SCHWEIZER SERVICE INFORMATION LETTER

REVISED NOTICE NO.: L-188a.

SUBJECT: 269A1231 MAIN ROTOR BEARING SET DELIVERED ON OR AFTER JUNE 17, 2021.

MODELS AFFECTED: 269A, 269A-1, 269B, 269C, 269C-1, AND 269D MODEL HELICOPTERS.

FIGURE 1 - "Inspection of Pitch Bearing Assembly"

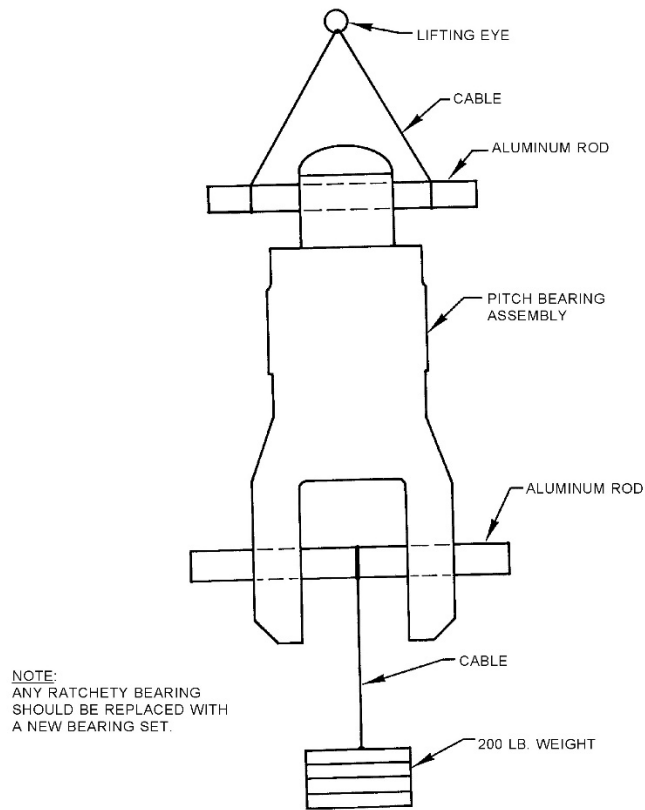
HISTORICALLY THERE HAS BEEN SOME ISSUES WITH MAIN ROTOR BLADE PITCH BEARINGS AND BEARING LIFE. SOME 269 OWNERS HAVE EXPERIENCED A SHORT REPLACEMENT LIFE OF THE PITCH BEARINGS DUE TO A ROUGH ROTATION OR BRINELLING MARKS ON THE BEARING. IN AN EFFORT TO PROLONG BEARING LIFE, SCHWEIZER RSG (SRSG) HAS COMPLETED A THOROUGH EXAMINATION WITH A VARIETY OF SIKORSKY OLD STOCK AND SCHWEIZER NEW PITCH ASSEMBLIES. THE RESULT OF THIS EXAMINATION, HAS DISCOVERED THAT MOST BEARING MANUFACTURERS PRODUCE THESE BEARINGS WITH AN SLIGHT OFFSET BETWEEN THE BEARING'S INNER AND OUTER RACES. SRSG HAS RECORDED THE OFFSET BETWEEN THE BEARING BRANDS AND HAS DETERMINED THE MOST CONSISTENT BEARING MANUFACTURER AND HAVE COME UP WITH A SOLUTION TO EXTEND BEARING LIFE. UNFORTUNATELY, IT DOES NOT CORRECT ALREADY DAMAGED BEARINGS. WHEN REPLACING PITCH BEARING USING NEW BEARINGS DELIVERED ON OR AFTER JUNE 17, 2021, IT IS NECESSARY TO FOLLOW THE HMI SECTION 8-26 TO DETERMINE IF THERE IS AN ISSUE OF ROUGHNESS AFTER ASSEMBLY OR STICK VIBRATION DURING GROUND RUN UP. REFERENCE "NOTE" IN SECTION 8-26, PAGE 8-37. IF THIS CONDITION IS NOTICEABLE THERE IS A POSSIBILITY THAT THE 269A1205-BSC SPACER MAY NEED TO BE REPLACED.

(REF.: HMI FIGURE, "INSPECTION OF THE PITCH BEARING ASSEMBLY", FIGURE 8-23 IN CSP-C-2, FIGURE 8-18 IN CSP-C-10, CSP-C1-2 & CSP-D-9; FIGURE 8-17 IN CSP-D-2, AND FIGURE 9-18 IN MSP-D-15).

IF A BINDING OR RATCHETING IS DISCOVERED WITH THE NEW BEARINGS, SRSG HAS DEVELOPED A PROCEDURE FOR REPLACING THE EXISTING PITCH BEARING SPACER WITH A NEW, LONGER BEARING SPACER. FOR ALL NEW PURCHASES OF 269A1231 BEARINGS FROM THE ABOVE DATE AND THAT HAVE ISSUES OF BINDING AND RATCHETING, SCHWEIZER RSG WILL PROVIDE A NEW 269A1205 BEARING SPACER.

TO REPLACE THE BEARING SPACER, SEND THE SUSPECT PITCH BEARING ASSEMBLY, P/N 269A1221 IN TO YOUR NEAREST AUTHORIZED SCHWEIZER SERVICE CENTER SO THAT THEY BE PROPERLY FITTED. *SOME ADDITIONAL FEES MAY APPLY.*
